**NAVFAC SPECIFICATION
08-1428**

AMENDMENT NO. 0003

14. DESCRIPTION OF AMENDMENT/MODIFICATION (Organized by UCF section headings, including solicitation/contract subject matter where feasible.) P1227,BEQ WOUNDED WARRIOR BATTALION, MCB, CAMP LEJEUNE, NORTH CAROLINA RECEIPT OF PROPOSALS REMAINS 7 NOVEMBER 2008 @ 2:00 PM NO MORE BID INQUIRIES WILL BE RECEIVED. SEE CONTINUATION SHEET sharon.taylor@navy.mil					
Except as provided herein, all terms and conditions of the document referenced in Item 9A or 10A, as heretofore changed, remains unchanged and in full force and effect.					
15A. NAME AND TITLE OF SIGNER (Type or print)			16A. NAME AND TITLE OF CONTRACTING OFFICER (Type or print)		
			TEL: _____ EMAIL: _____		
15B. CONTRACTOR/OFFEROR _____ (Signature of person authorized to sign)	15C. DATE SIGNED	16B. UNITED STATES OF AMERICA BY _____ (Signature of Contracting Officer)		16C. DATE SIGNED 28-Oct-2008

AMENDMENT 0003

MECHANICAL FLOOR PLAN

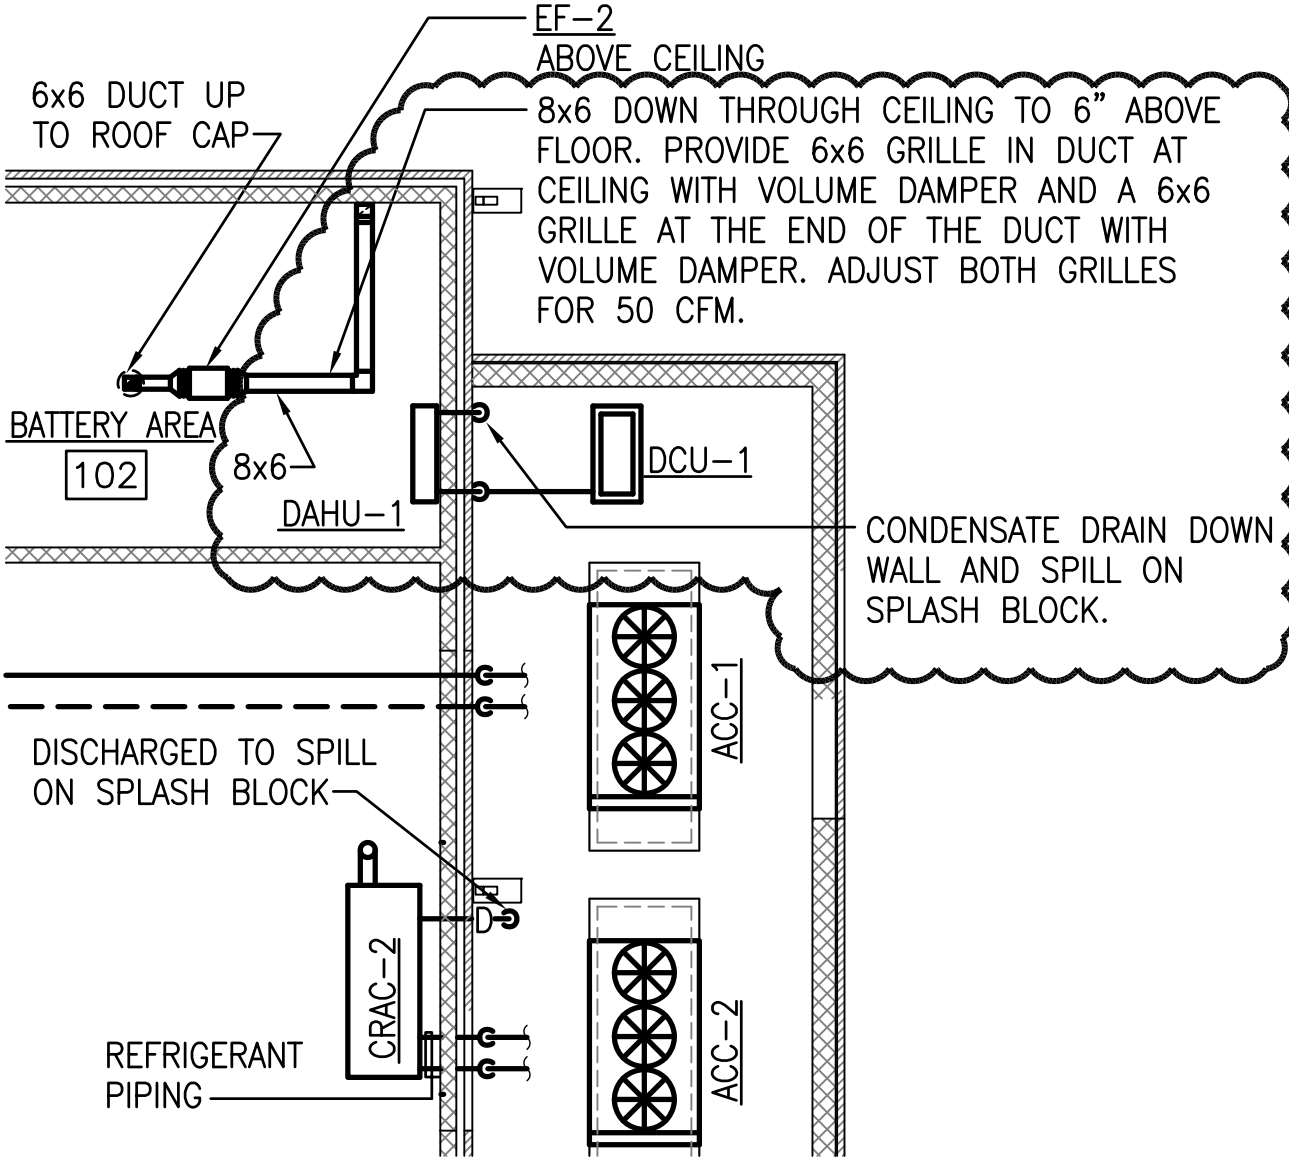
Sketch SKM2-002 is added to the list of drawings. This sketch accompanies this Amendment. Mechanical Floor Plan. The exhaust fan -2 ductwork shall be modified as shown. Addition of DAHU-1 and DCU-1 with interconnecting refrigerant piping and condensate drain. EW-2 is eliminated.

MECHANICAL FLOOR PLAN

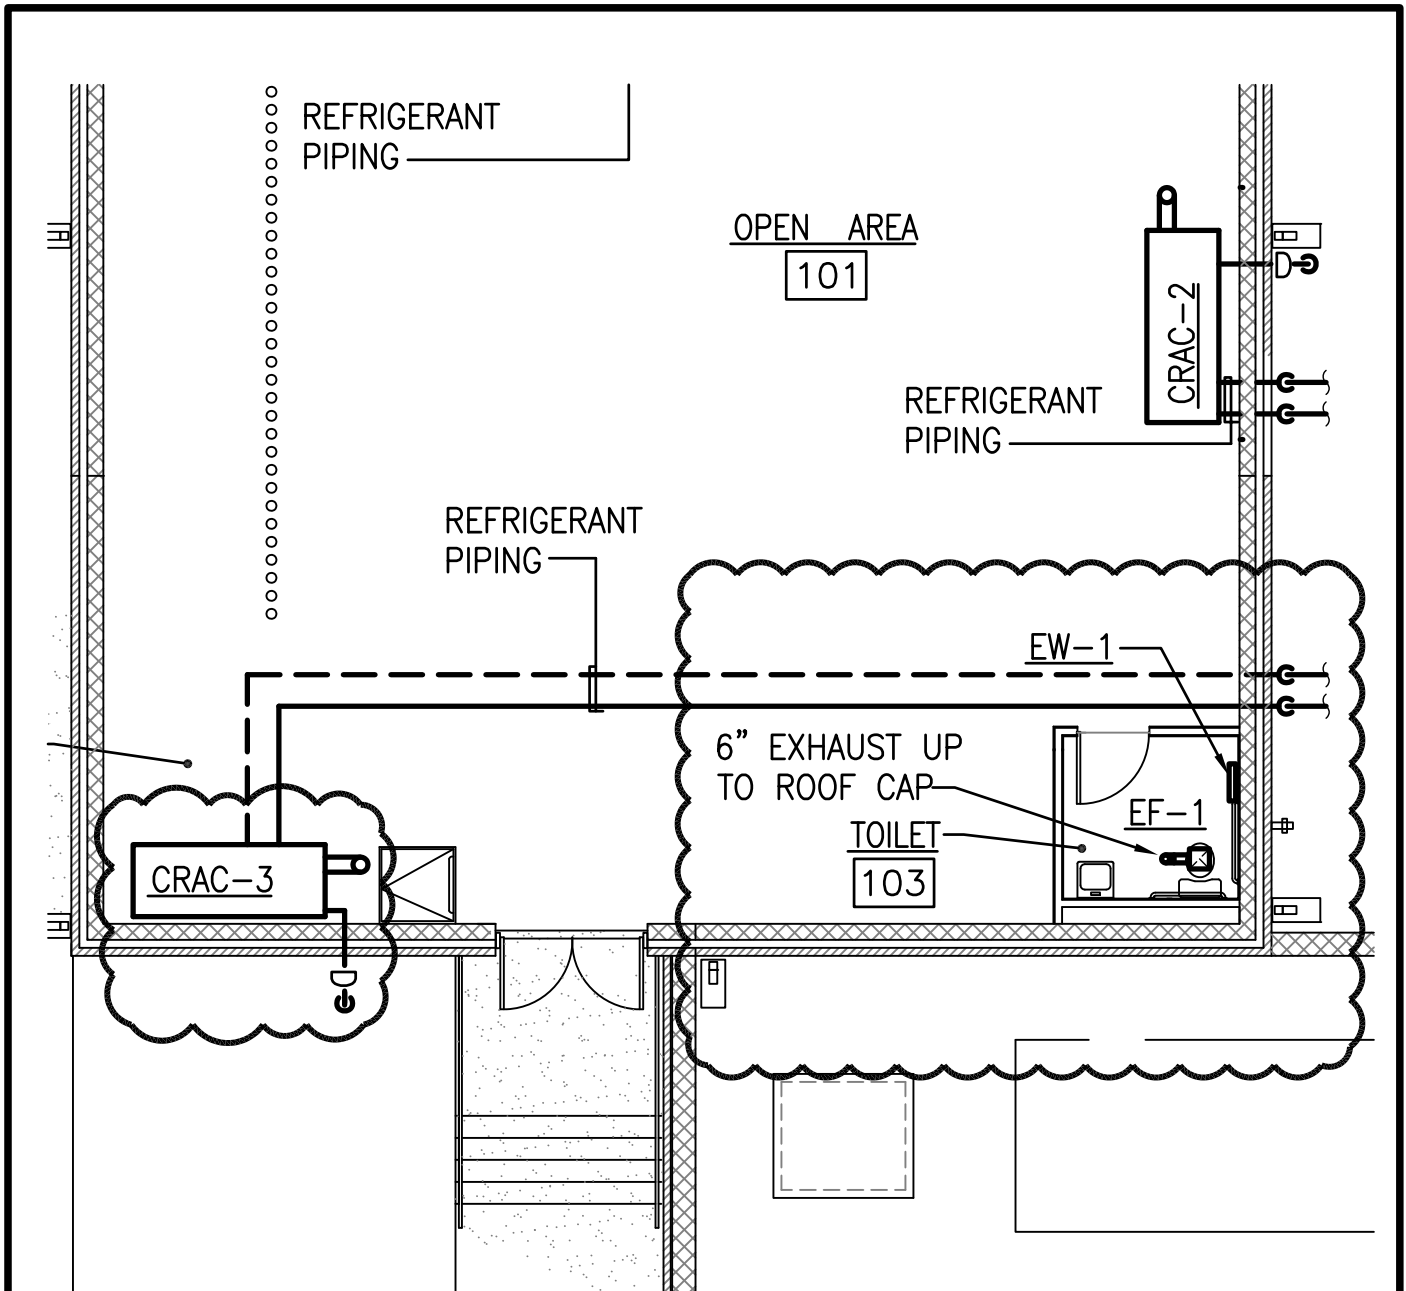
Sketch SKM2-003 is added to the list of drawings. This sketch accompanies this Amendment. Mechanical Floor Plan. The electrical heater, EW-1, in Toilet 103 is relocated. CRAC-3 is relocated.

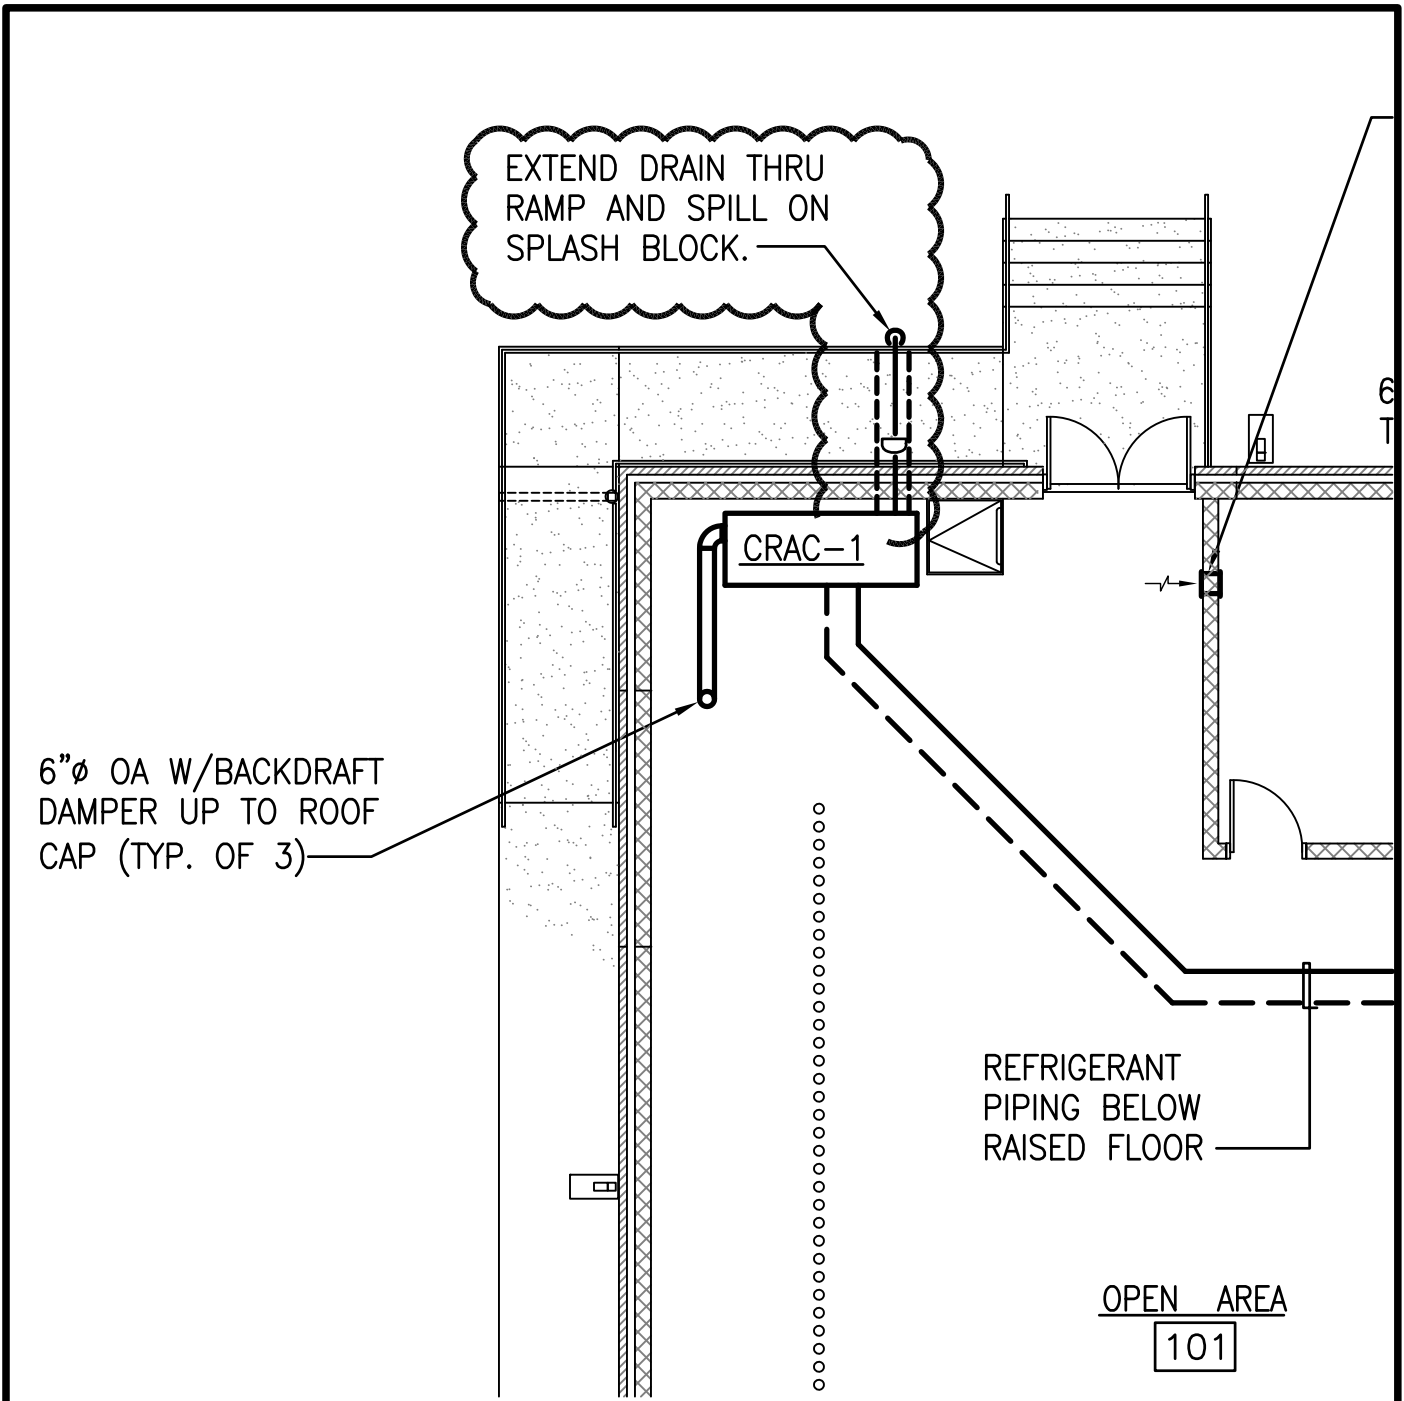
Sketch SKM2-004 is added to the list of drawings. This sketch accompanies this Amendment. Mechanical Floor Plan. The condensate drain is modified through the exterior ramp.
